Riley-Purgatory-Bluff Creek Watershed District
Board of Managers Public Hearing

Monday, May 15, 2017 – 6:00pm
PBCWD District Office
18681 Lake Drive East
Chanhassen

Re: Plan Amendment: Bluff Creek Southwest Branch

7.4a.7 Bluff Creek Southwest Branch Stabilization and Restoration

BLUFF CREEK REACH #73A
Bluff Creek Feasibility Study
Riley Purgatory Bluff Creek Watershed District

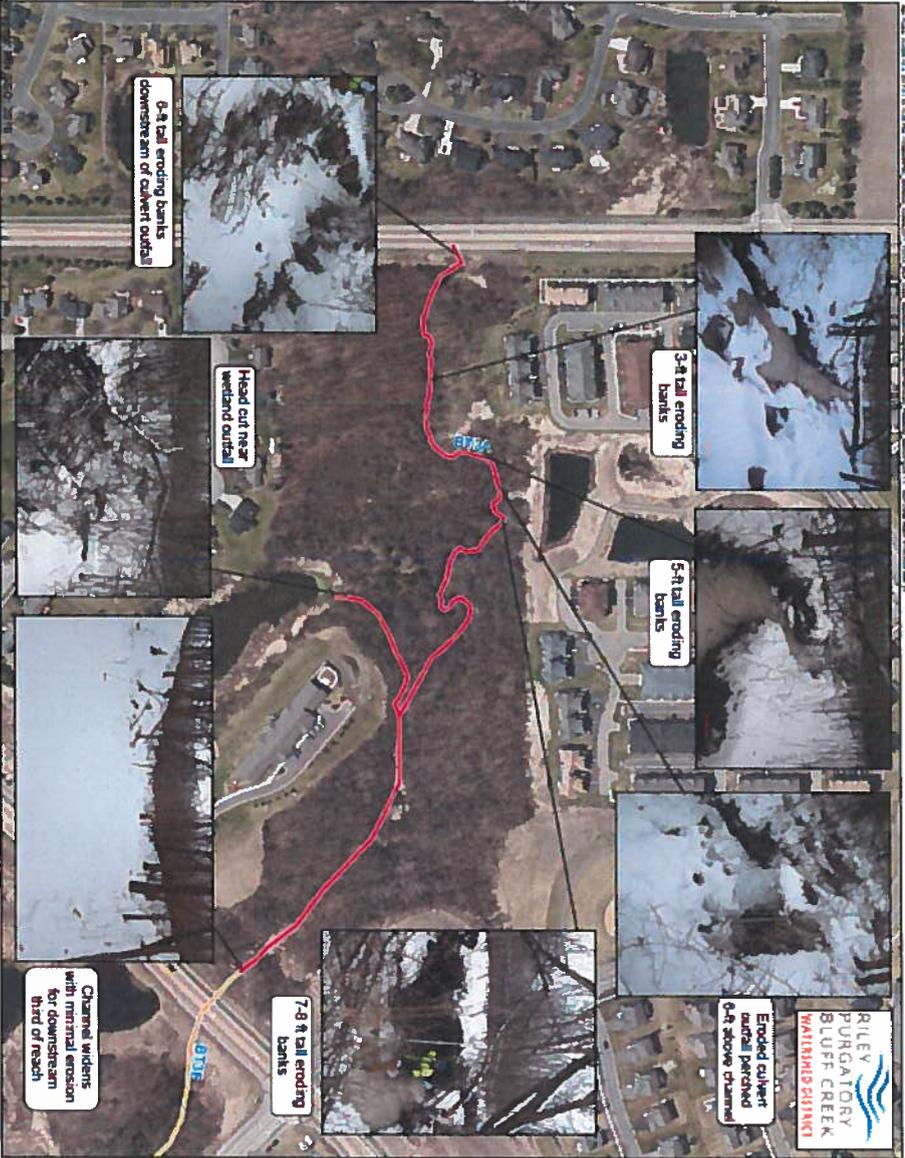
She suggests that the 5th paragraph (below) is not clearly stated. She also recommends that a figure to illustrate what is occurring would be helpful in describing what is occurring .

However, in arecent field visit 1 12-inch culvert from a stormwater pond outlet in the left overbank of this reach is severely eroded and perched approximately 6 feet above the channel bed. An adjacent wetland located south of the project reach has a natural overflow point that contributes flow to a secondary tributary. Significant channel incision has occurred in this tributary with a 4 to 5 foot tall headcut very near the tributary origin from the wetland. Continued migration of the headcut to the wetland could result in draining the wetland.

A description of the methods for the proposed work is recommended, or at a minimum, perhaps discussion that the minimal impact solution will be selected for implementation.

However, in a recent field visit, one 12-inch culvert from a stormwater pond outlet in the left overbank of this reach is severely eroded and perched approximately 6 feet above the channel bed. An adjacent wetland located south of the project reach has a natural overflow point that contributes flow to a secondary tributary. Significant channel incision has occurred in this tributary with a 4 to 5 foot tall headcut very near the tributary origin from the wetland. Continued migration of the headcut to the wetland could result in draining the wetland. The attached Figure 1-2 from the Bluff Creek Stream Stabilization Assessment shows both the perched culvert and the headcut near the wetland.

cut moving toward the wetland will be stabilized with grade control to prevent further migration of the head cut toward the wetland. Specific approaches and techniques for both the main channel and the tributary from the wetland will be determined during final design; however natural-looking techniques that minimize disturbance are preferred.

1 OVERALL GRADING PLAN
L4.0 1"=60'

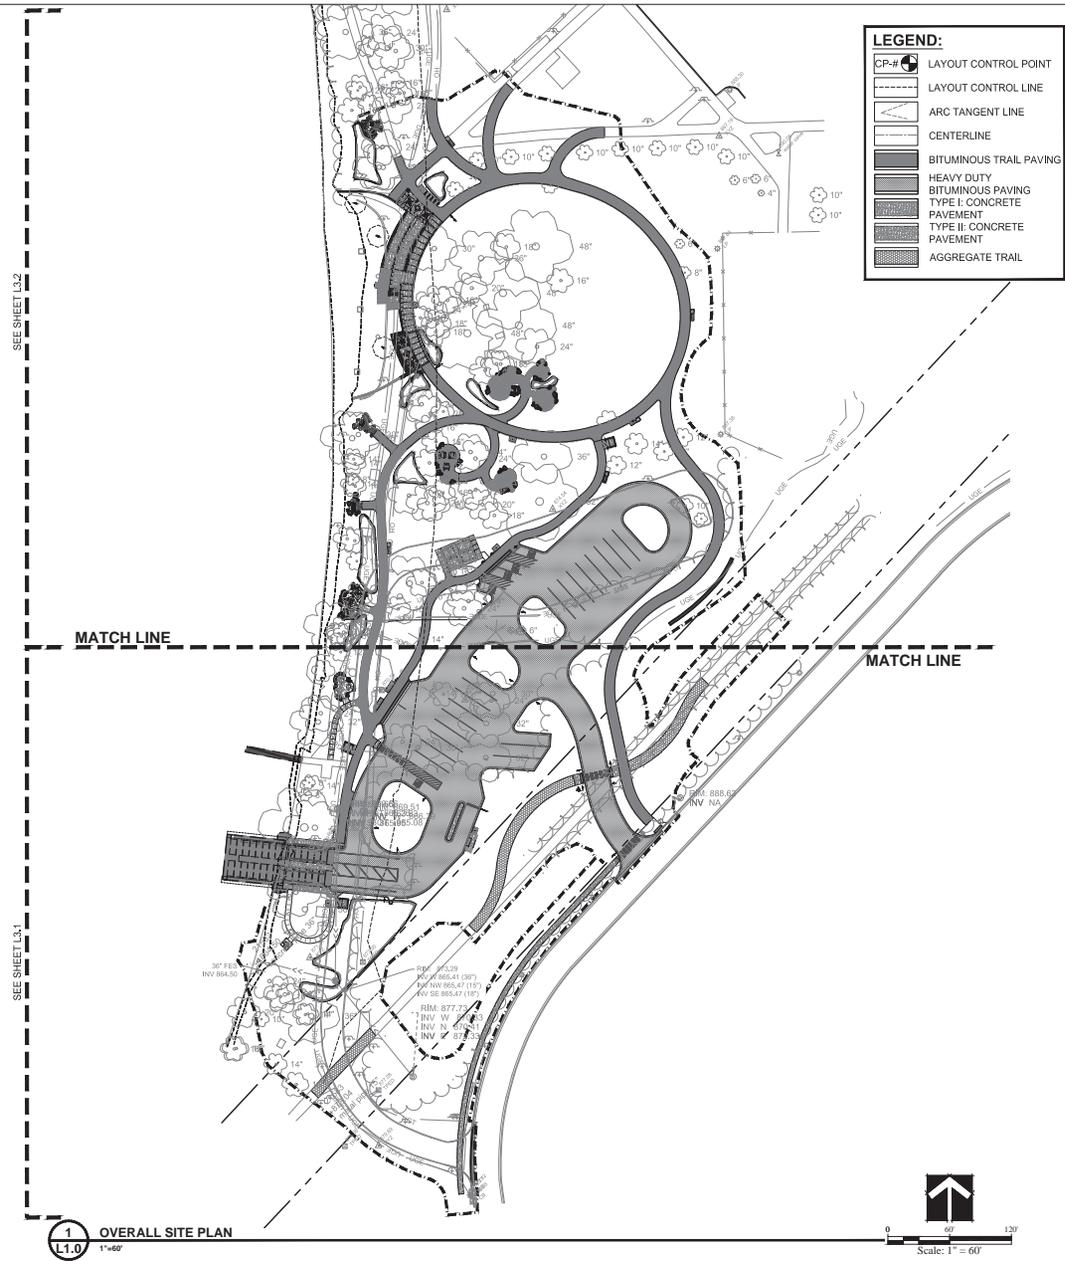
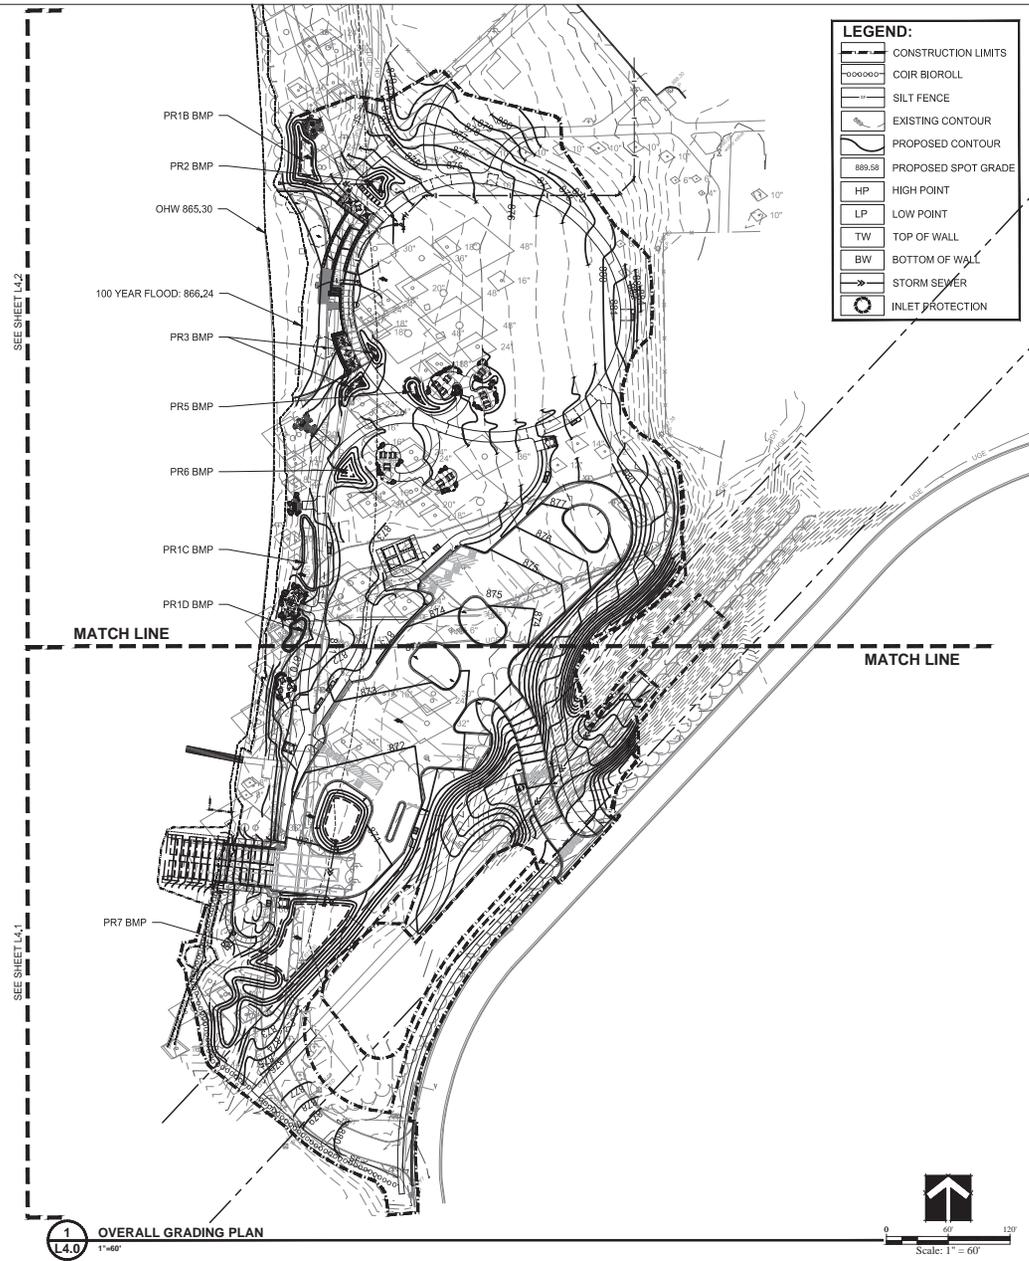
3. Update Plan sheet L4.5 to include a rock construction entrance for the Jacques Barn Infiltration Basin site.
4. The erosion control plan must be updated to include the following note:
